# UNITED STATES PATENT AND TRADEMARK OFFICE

APPLICATION NO.	FILING DATE	FIRST NAMED INVENTOR	ATTORNEY DOCKET NO.	CONFIRMATION NO.
10/631,227	07/31/2003	Joseph W. Works	123.01	1728

<b>Office Action Summary</b>	<b>Application No.</b> 10/631,227	<b>Applicant(s)</b> WORKS, JOSEPH W.	
	<b>Examiner</b> Paul Royal	<b>Art Unit</b> 3611

## **DETAILED ACTION**

Figure 1

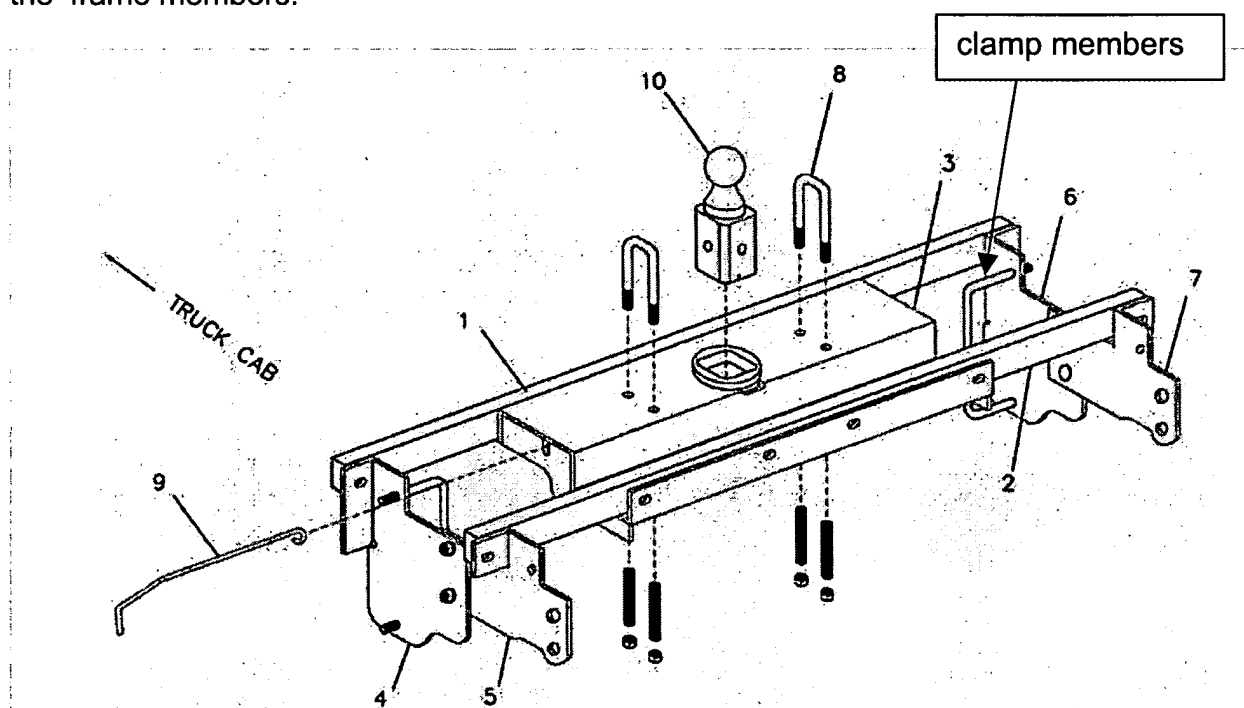
a pair of clamp members (clamp members, see Examiner annotated Figure 1) associated with each of the side plates, each pair of clamp members including a front clamp member and a rear clamp member, the front clamp member being engaged with an associated front side plate member and the rear clamp member being engaged with an associated rear side plate member, each pair of a front and a rear clamp member clampingly engaging a respective one of the side plates with an associated one of the frame members at such a location as to position the pin member in the associated preformed aperture,
